May 9, 2022 GS# 411-125 Main Campus Multipurpose Building East Mississippi State Hospital Meridian, MS

Addendum No. 1

End of Addendum No. 1 for: GS# 411-125 Main Campus Multipurpose Building

1 CLERESTORY PLAN

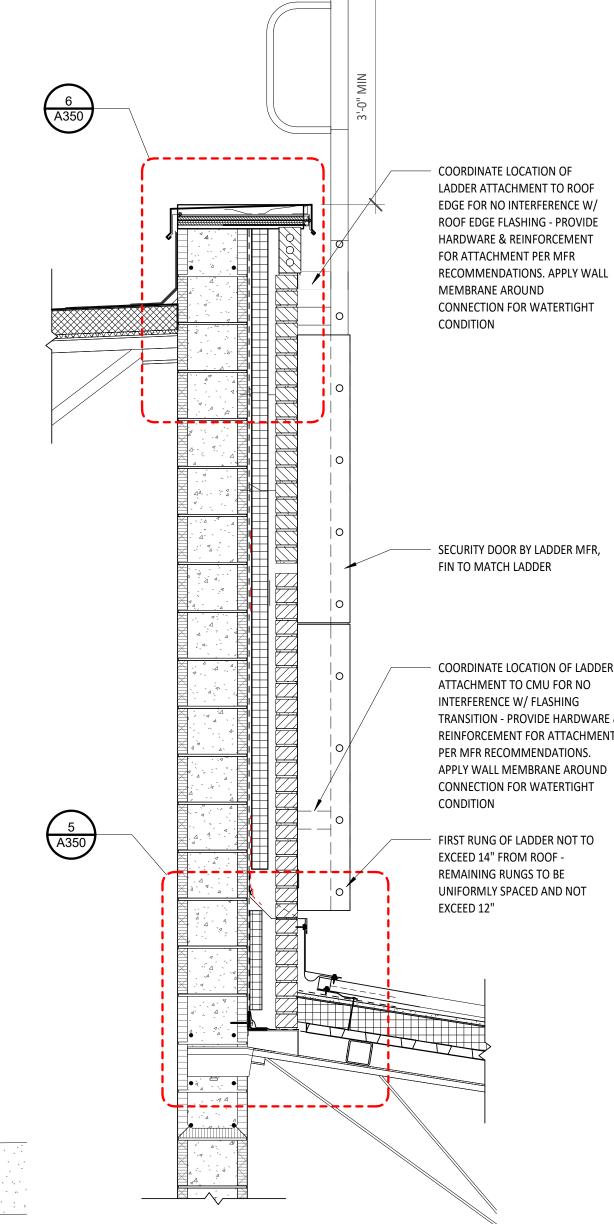
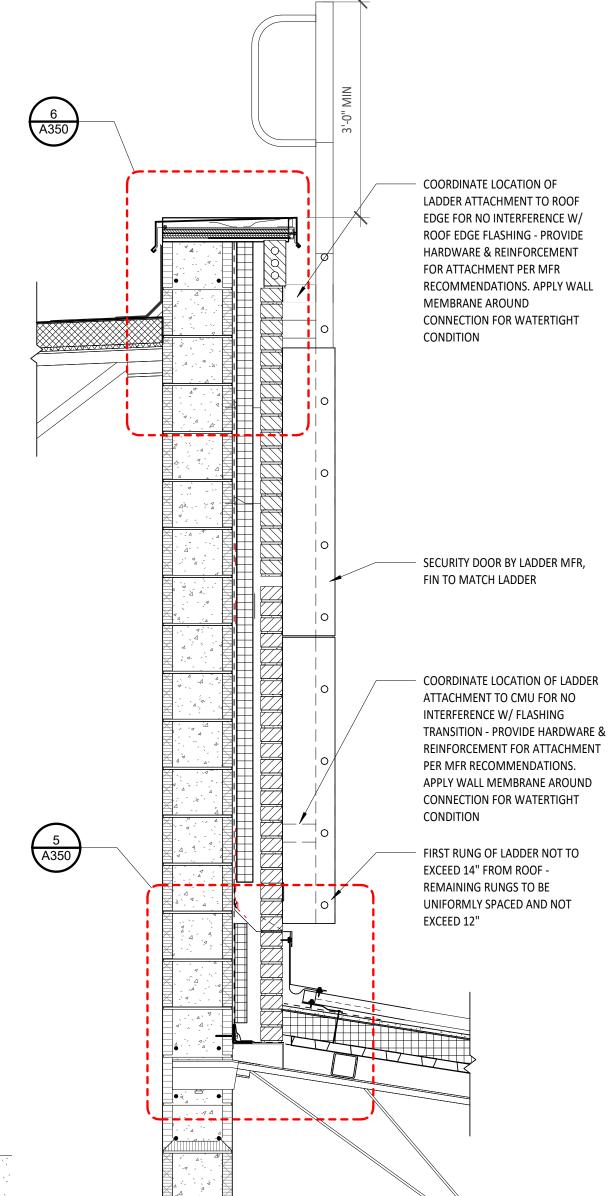
- a. Sheet C100: REPLACE with revised sheet C100R, see attached. Add temporary fence and gate locations, revise keynotes, clarify removal of additional tree.
- b. Sheet A111: REPLACE with revised sheet A111R, see attached. Add fixed roof access ladder.
- c. Sheet A400:
 - i. <u>Revise</u> 2/A400: Provide (1) Toilet Accessory 'D Sanitary Napkin Disposal' in each staff restroom shown
 - ii. Revise Keyed Note A: 'CENTER MIRROR OVER LAVATORY BELOW. SIZE AS SCHEDULED.'
- d. Sheet A401:
 - i. ADD note: "Both Projector and Projector Mount to be provided by Owner."
 - ii. Interior Elevations 2, 4 REVISE note for motor operated divider curtain: "MOTOR OPERATED DIVIDER CURTAIN MOUNTED TO STRUCTURAL SUPPORT. ATTACHMENT BY CURTAIN MANUFACTURER."
- e. Sheet A600: Delete Opening Schedule General Note 1.

PERMANENT ROOF ACCESS LADDER
